ADDENDUM NO. 01

Oak Hill United School Corporation – Multi-School MEP Improvements
405 South Washington St, Swayzee, IN 46986
7760 Delphi Pike, Converse, IN 46919
600 Walnut St, Converse, IN 46919

Addendum One (AD.01) to the drawings and specifications prepared by Gibraltar Design for **Mechanical Improvements Across Three Schools** for Oak Hill United School Corporation Converse, Indiana.

1 ED102 UNIT "B" FIRST FLOOR ELECTRICAL DEMOLITION PLAN
1/8" = 1'-0"

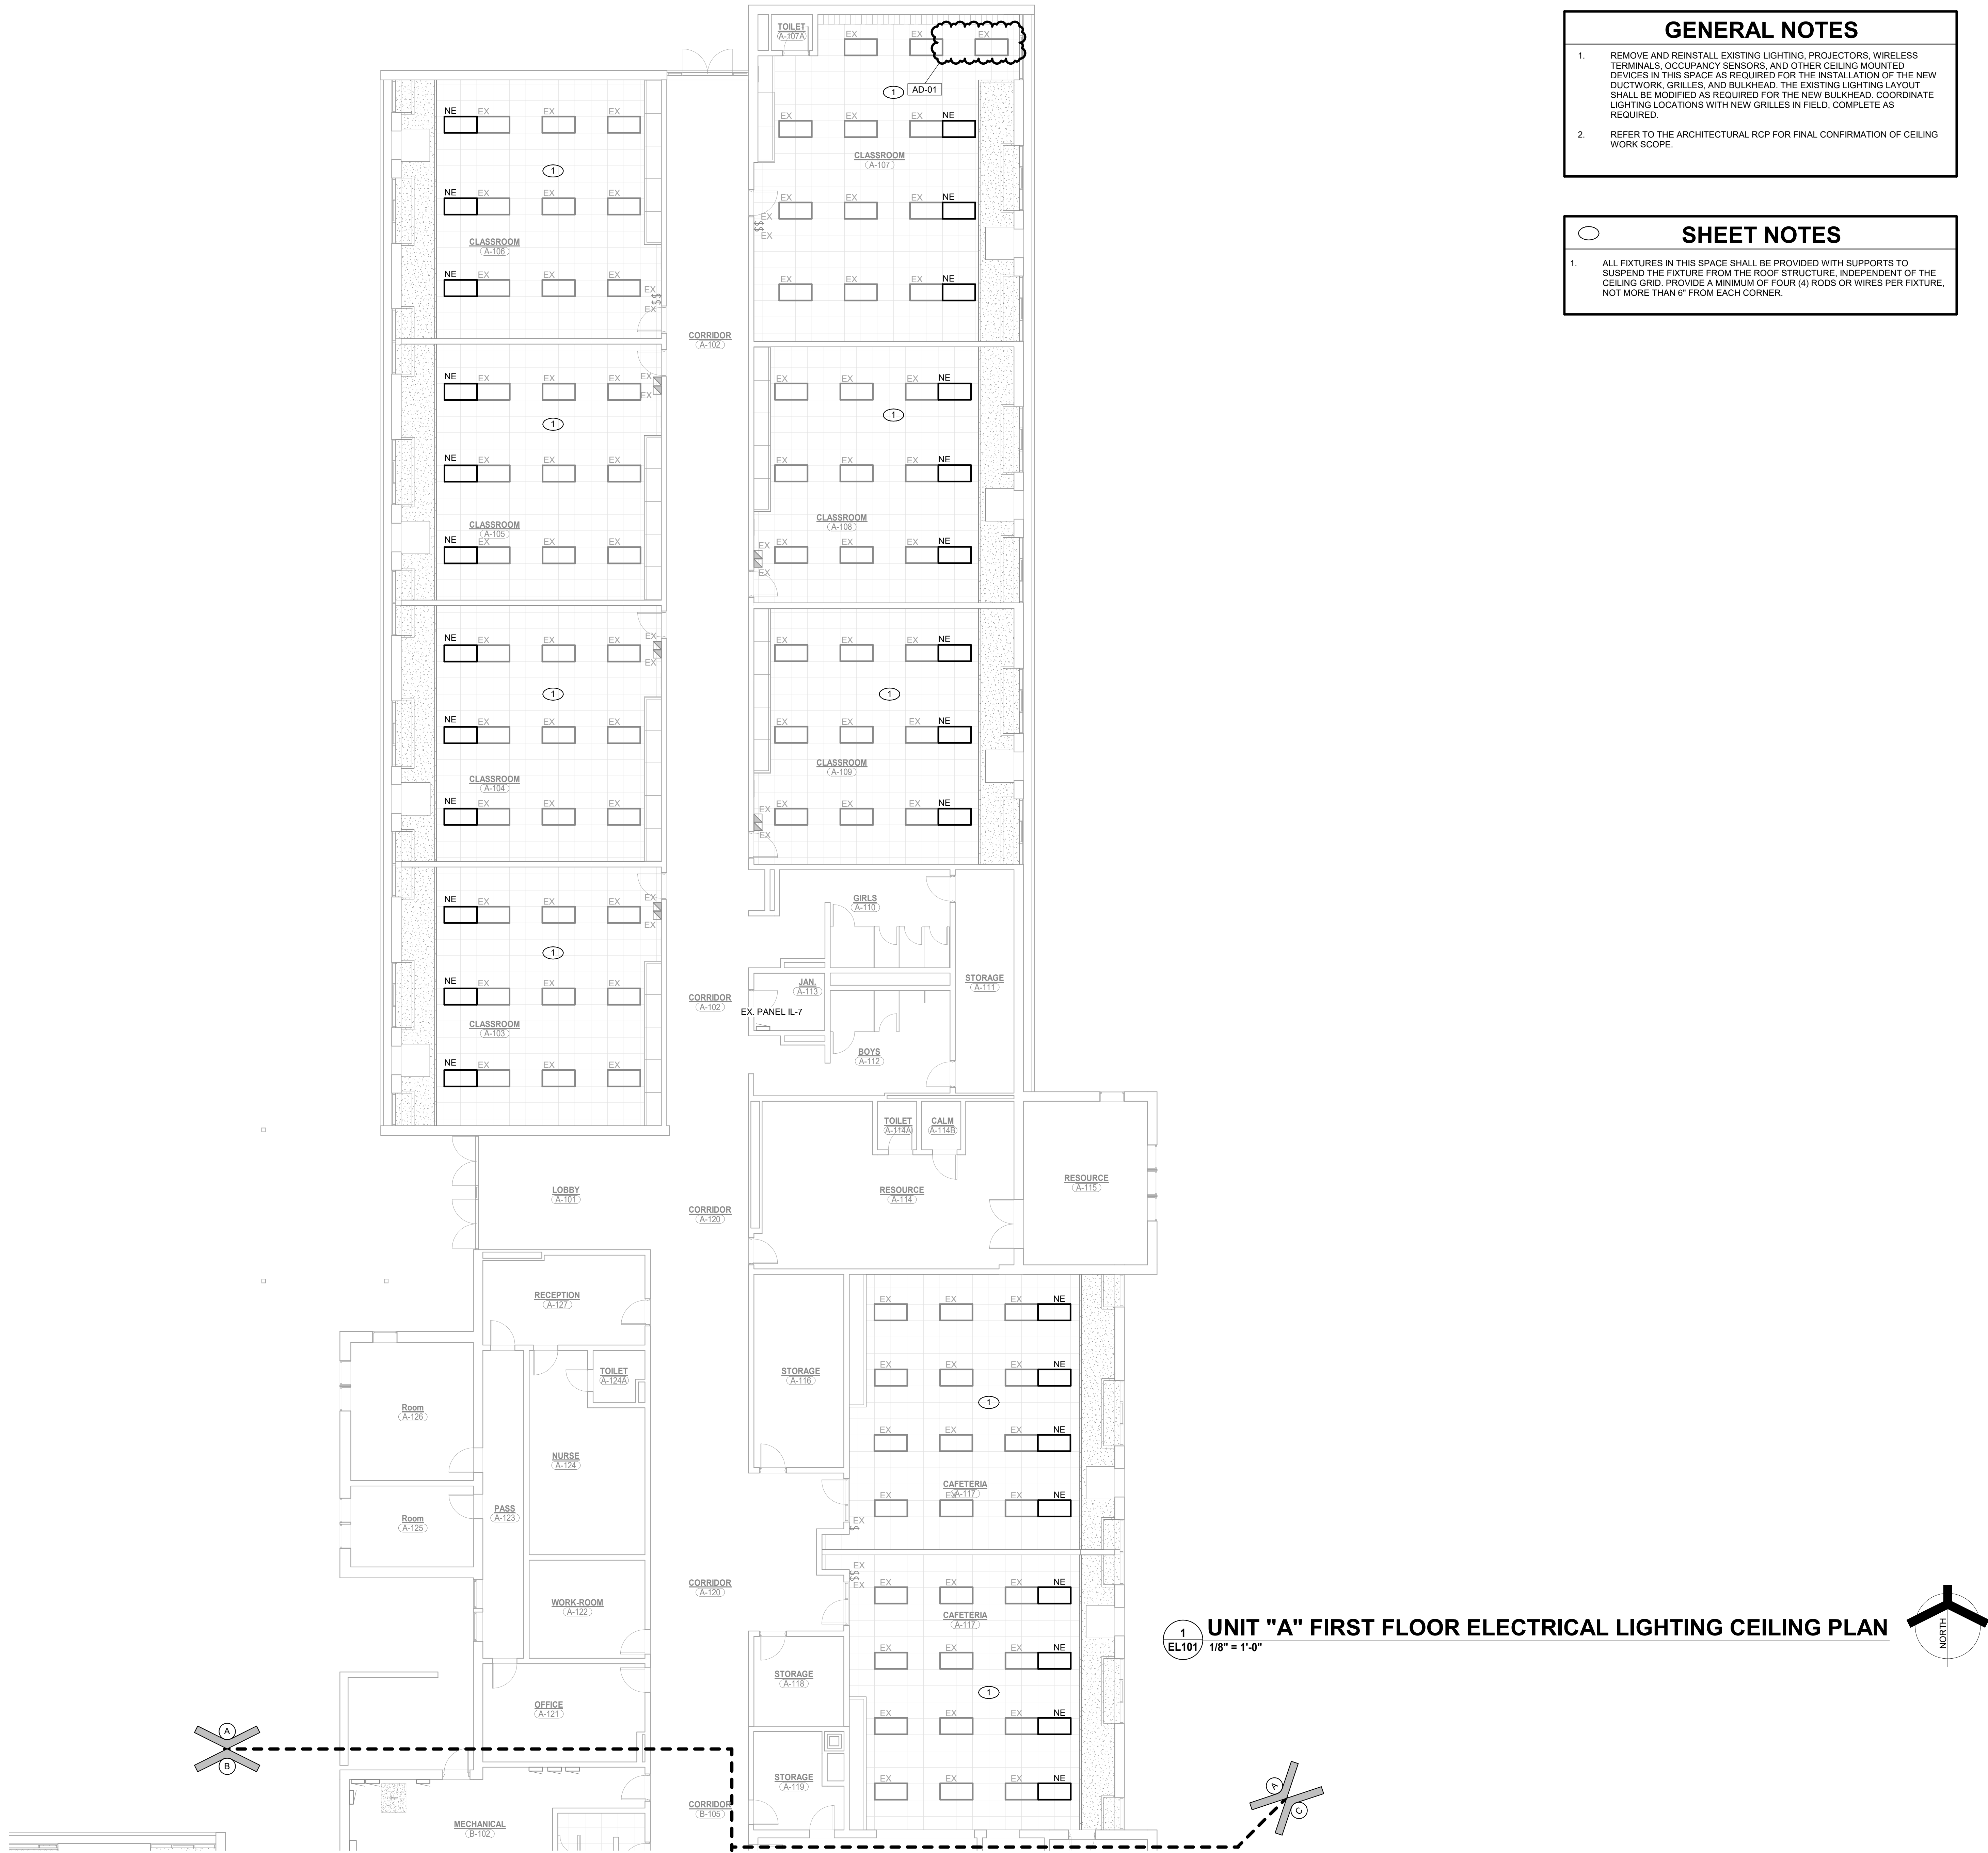
33. Sheet ED102

- A. Refer to revised, full-size drawing, included in this Addendum, for revisions.
 1. Added mechanical equipment to be removed and all associated notes.
 2. Revised lighting phasing.
 3. Added occupancy sensors.

1 UNIT "B" FIRST FLOOR MECHANICAL HVAC PLAN
M-102 1/8" = 1'-0"

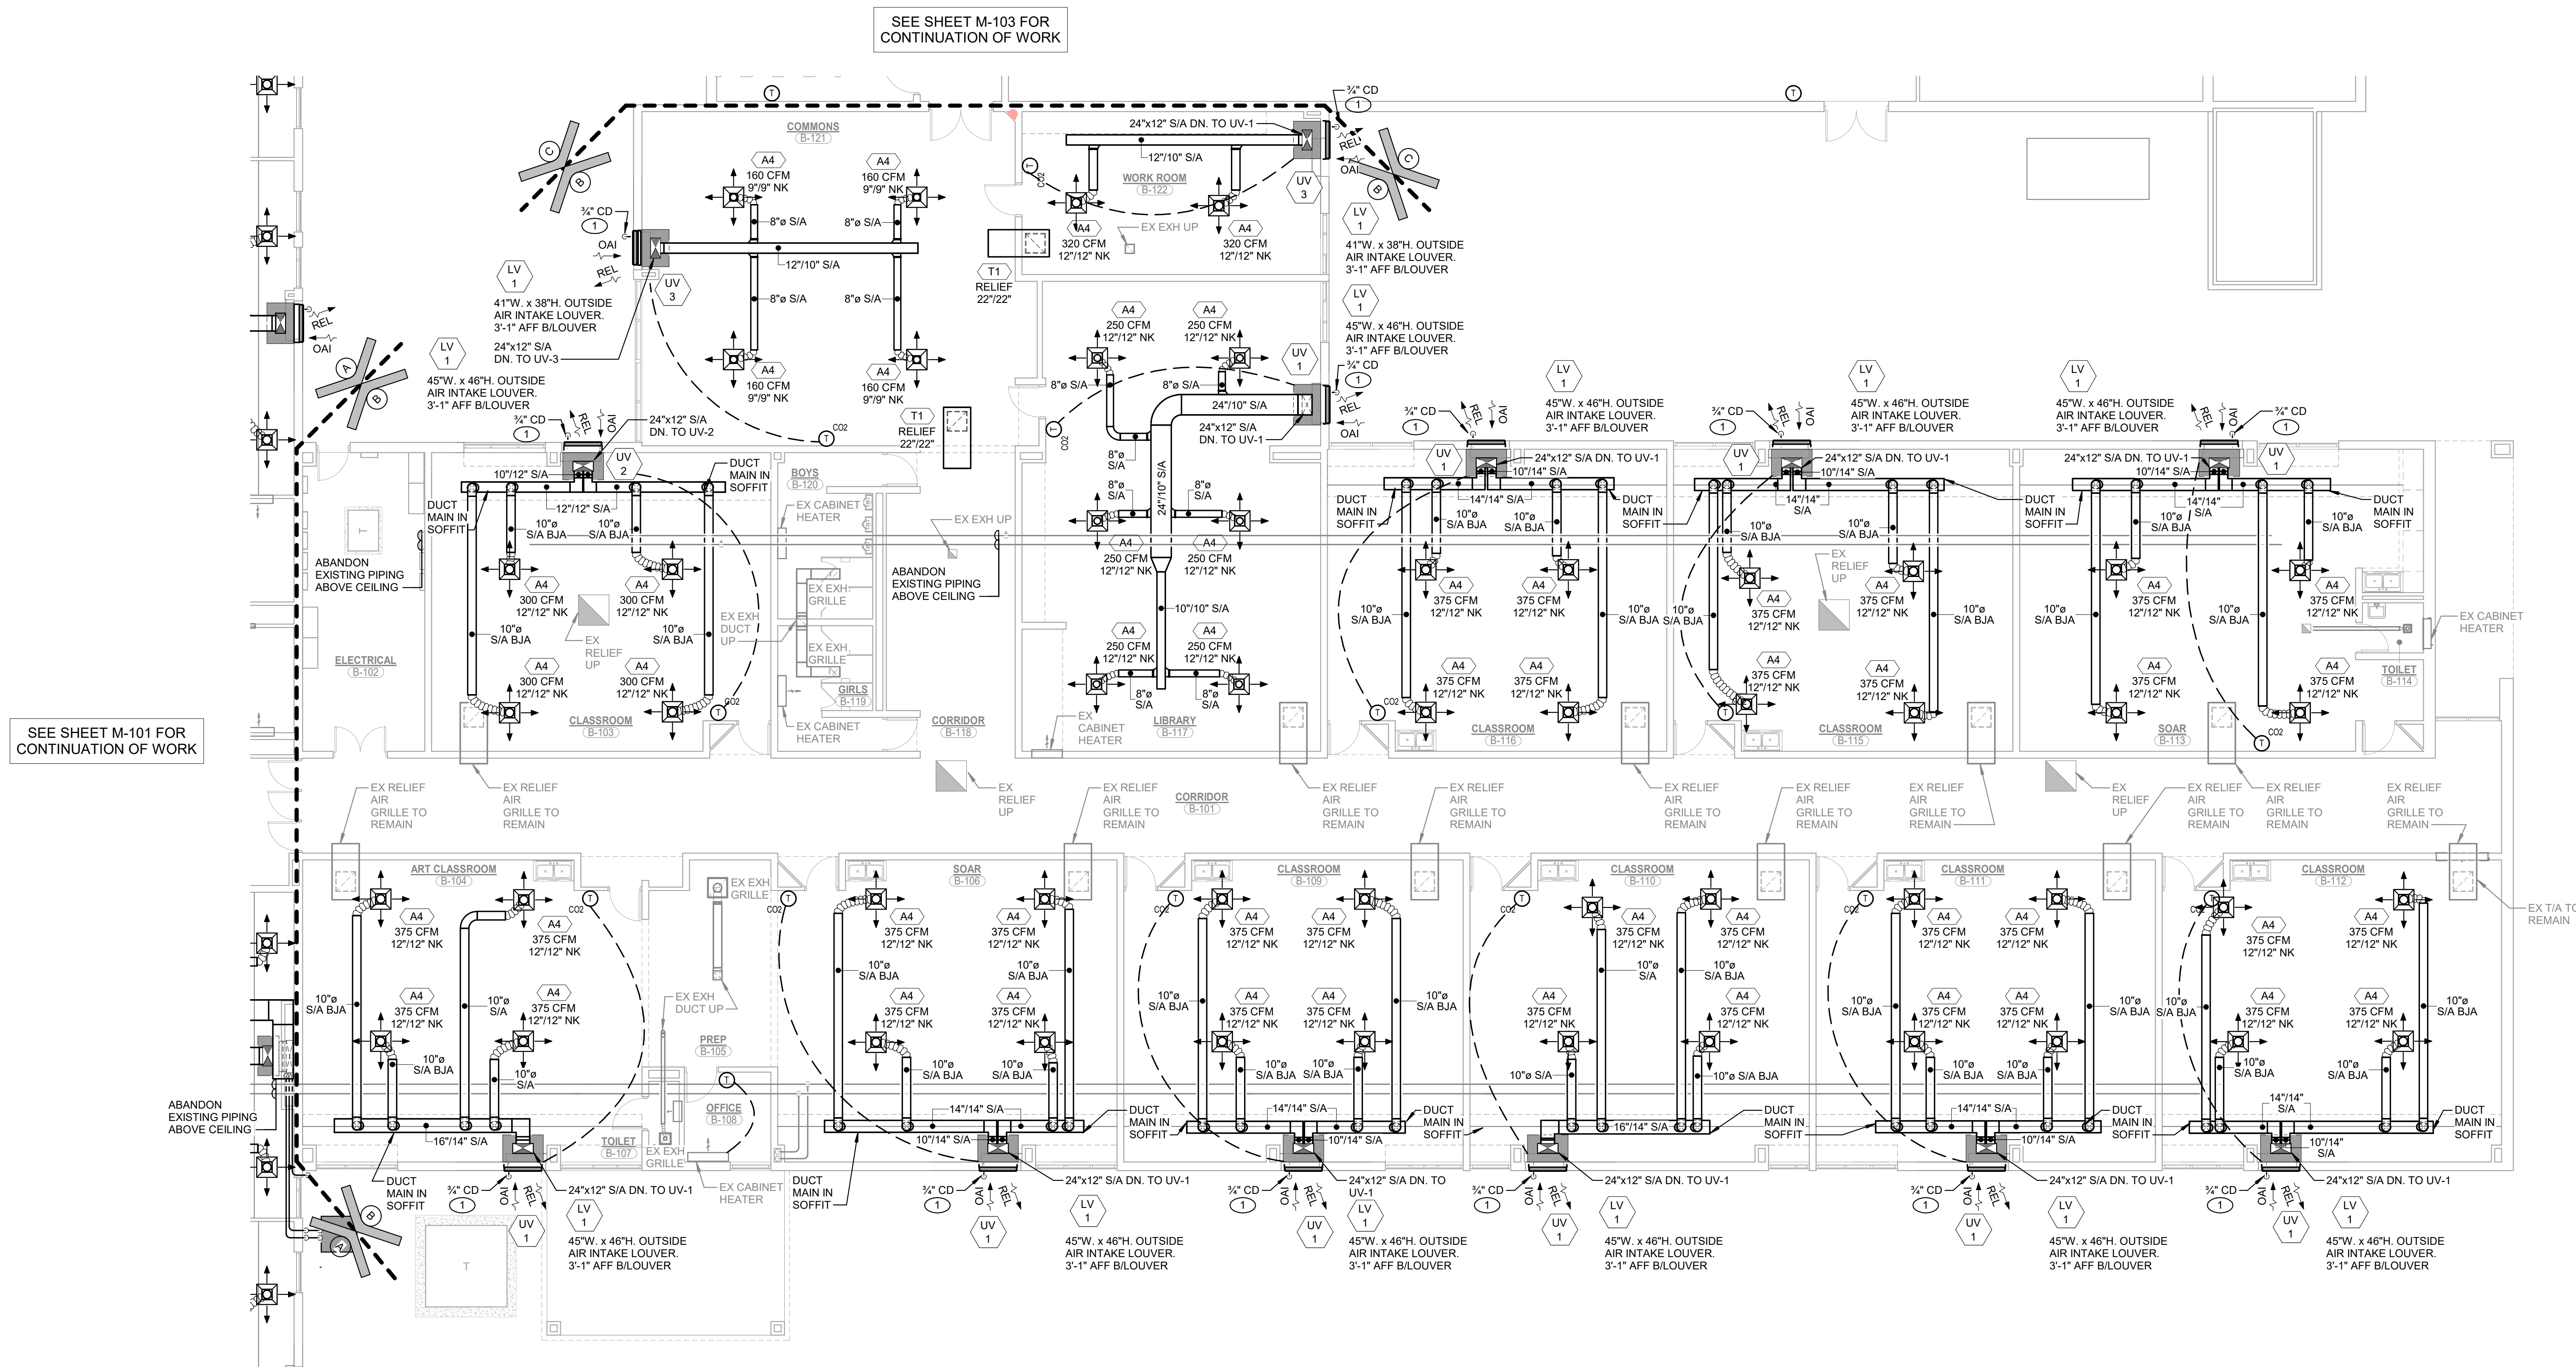
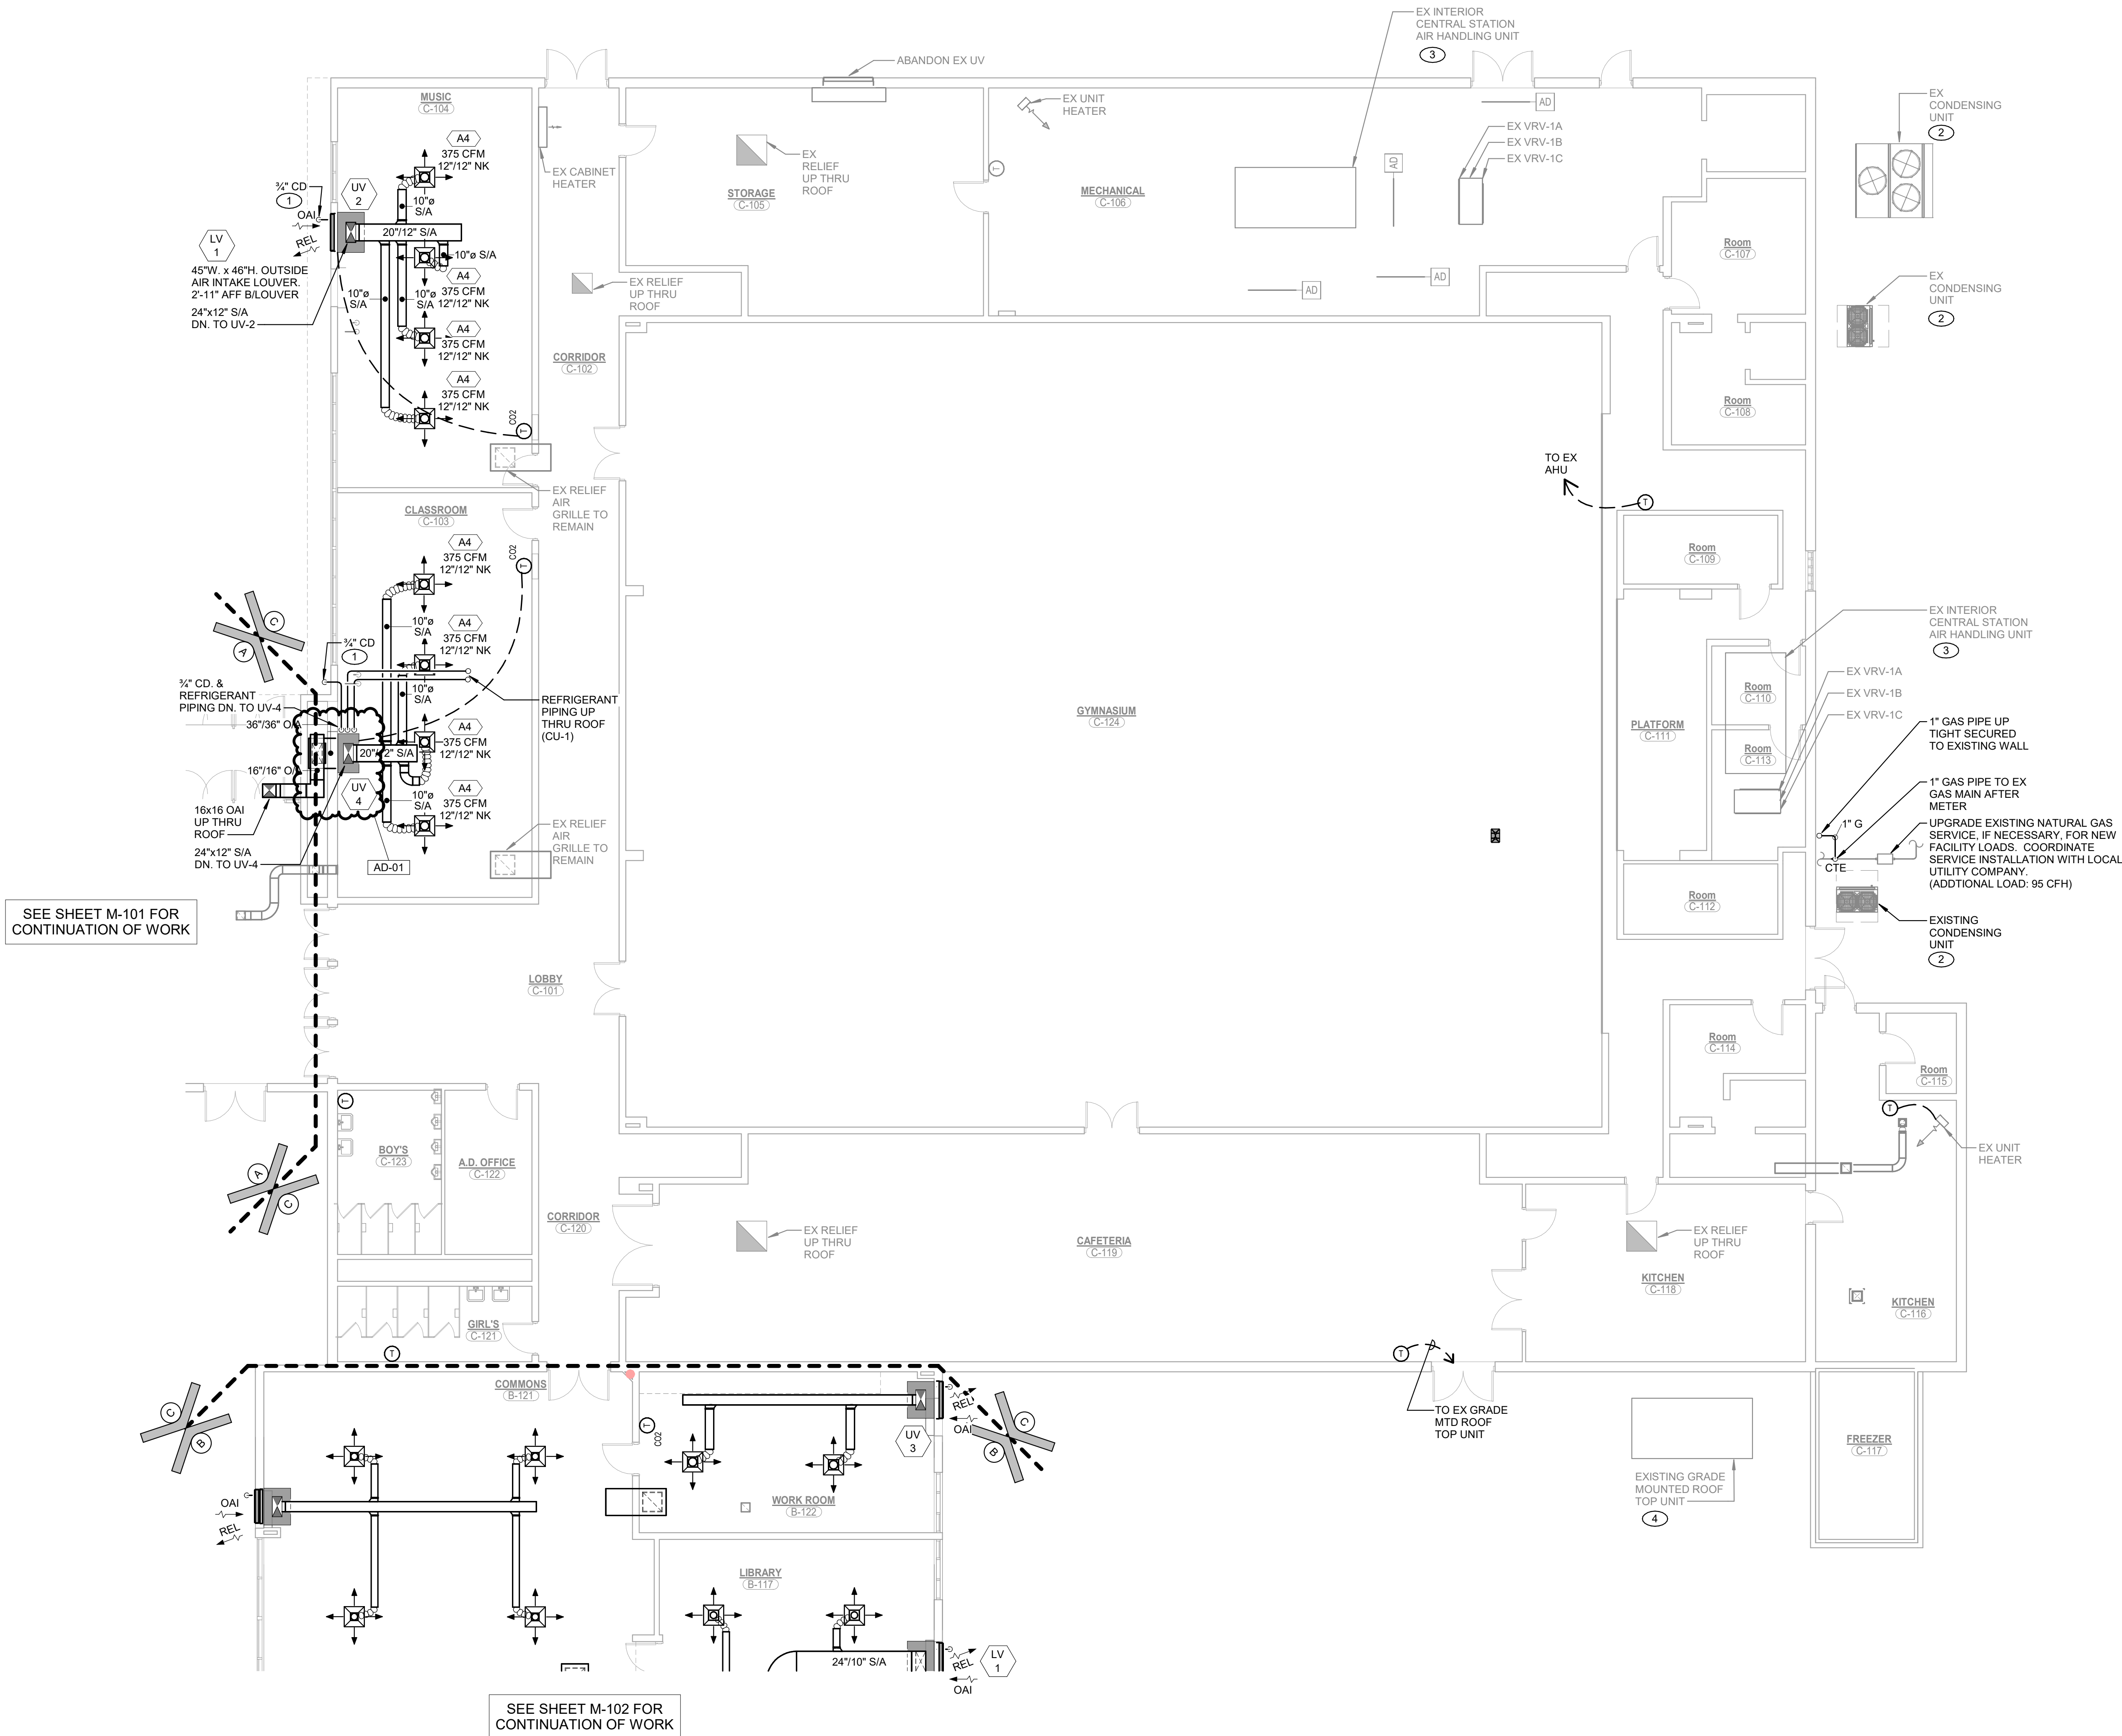
29. Sheet M-102

- A. Refer to revised, full-size drawing, included in this Addendum, for revisions.
 1. Modified sheet note No. 1.
